CRITICAL AREA BUFFER MANAGEMENT PLAN

RE: AN 50-07, Neal Ruchman Local Case #BOA 2007-1-837

Thank you for providing information on the above referenced variance application. The applicant is requesting a variance to the 100-foot Buffer. The parcel is 7,696 square feet, located in the Intense Development Area (IDA), and is currently improved with an existing house, garage, and paver driveway. The entire parcel is located within the 100-foot Buffer and is no longer designated by the City as Buffer Exemption Area (BEA). The applicant is proposing to construct an addition to the dwelling and add a deck. Currently, the existing structure is 42.5 feet landward of mean high tide, which will be maintained by the additional structure. However, the average setback from mean high tide of neighboring properties is 61.1 feet and the proposed deck will be located 33 feet landward.

The Ruchman Residence

PROPOSED SITE PLAN

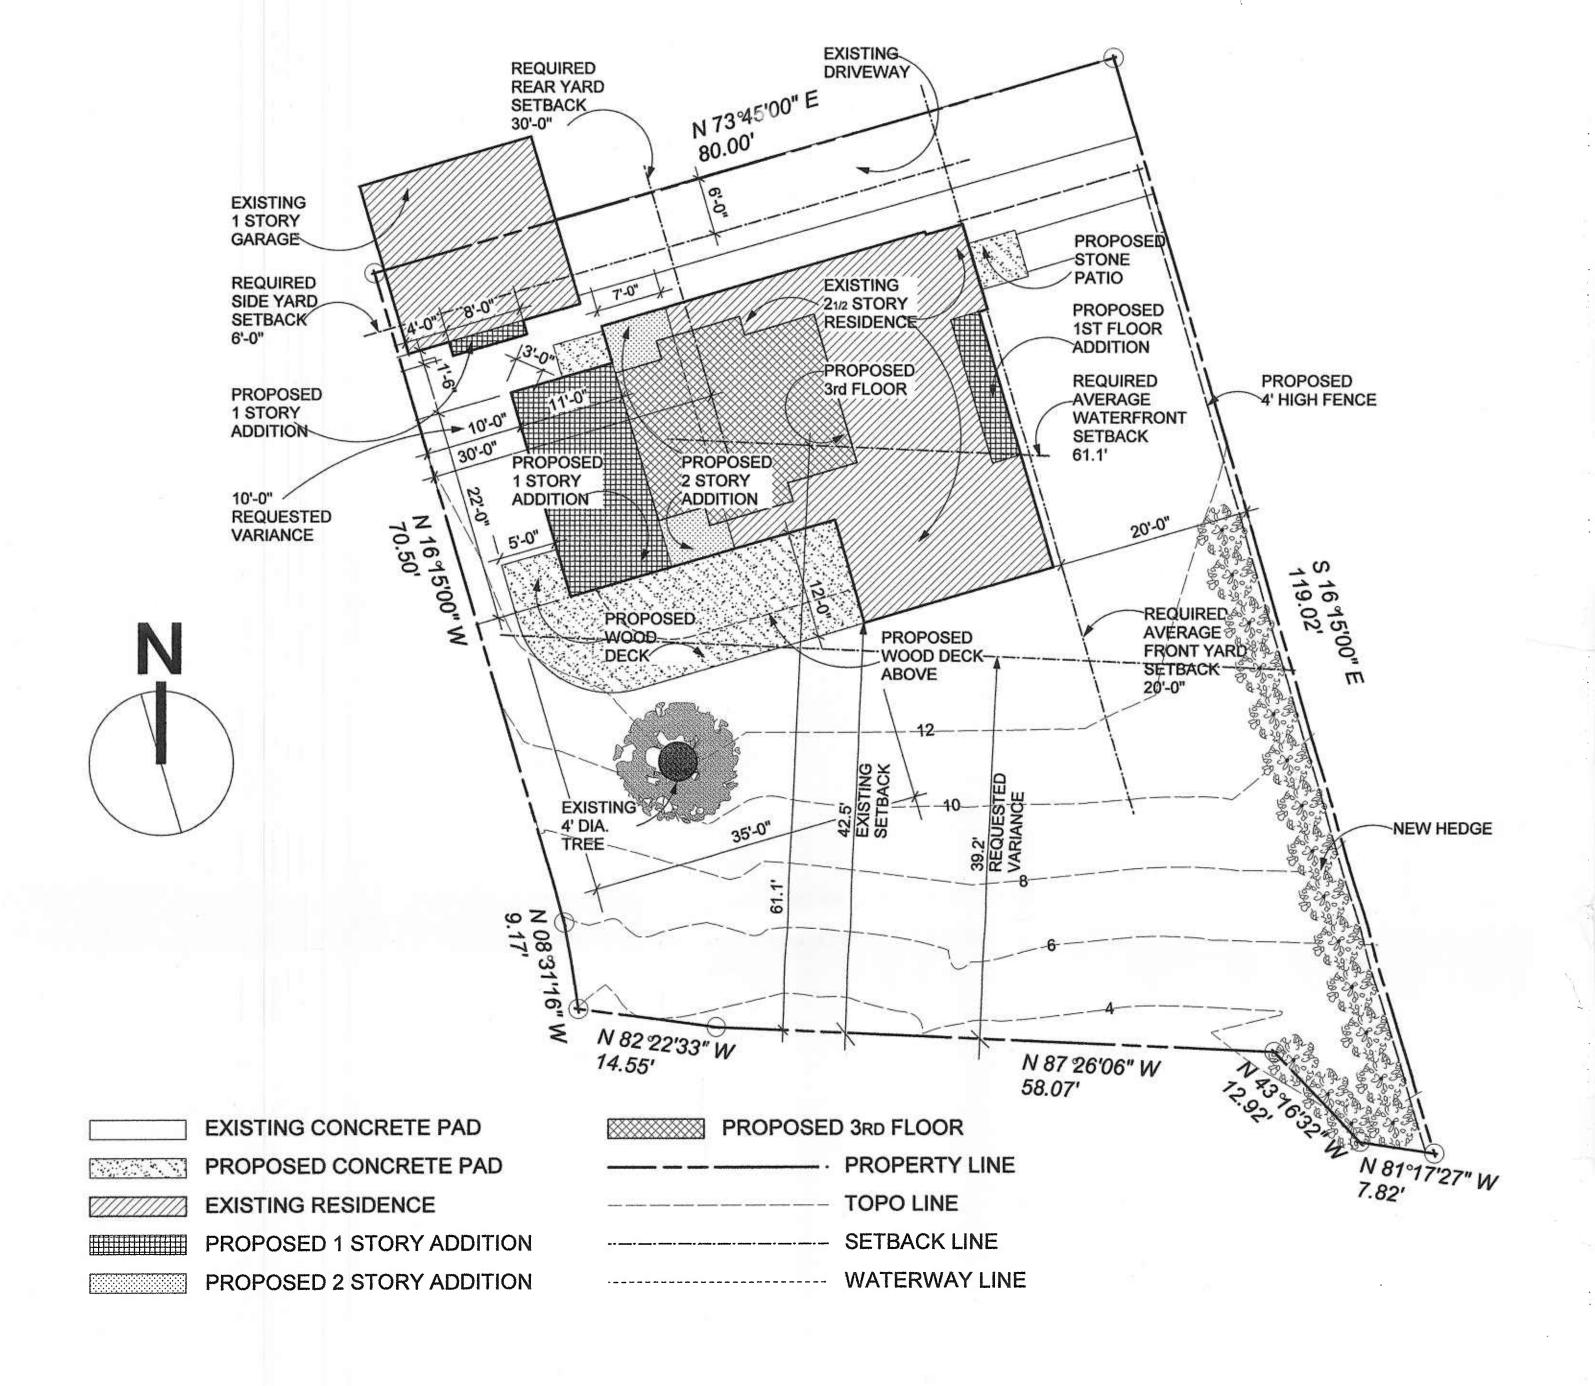
- 1. We recognize the unique configuration of the lot plays a role in the proposed 33-foot setback for the deck. This office recommends the deck be constructed to be pervious, with a gravel substrate throughout and vegetative stabilization at the perimeter.

- 2. The guidance for meeting 10% pollutant reduction on a single residential lot is to plant one tree or three shrubs for every 100 square feet (or portion thereof) of new impervious surface created. The site plan only shows 1 tree proposed to meet 10% for 293 square feet. Therefore, the applicant should revise the planting plan to reflect the above guidance.

- 3. The submitted Buffer Management Plan shows mitigation only for 160 square feet of area of buffer disturbed. However, the site plan states that 1,773 square feet of disturbance will occur within the Buffer. The guidance is clear that even if no trees are cleared, Buffer disturbance is

based on area cleared/disturbed. The applicant should revise the submitted Buffer Management Plan to provide 3:1 mitigation for 1,773 square feet.

4. At a minimum 1:1 of the required 3:1 Buffer mitigation should be planted within the 100-foot Buffer in addition to the plantings required to meet the stormwater requirement.
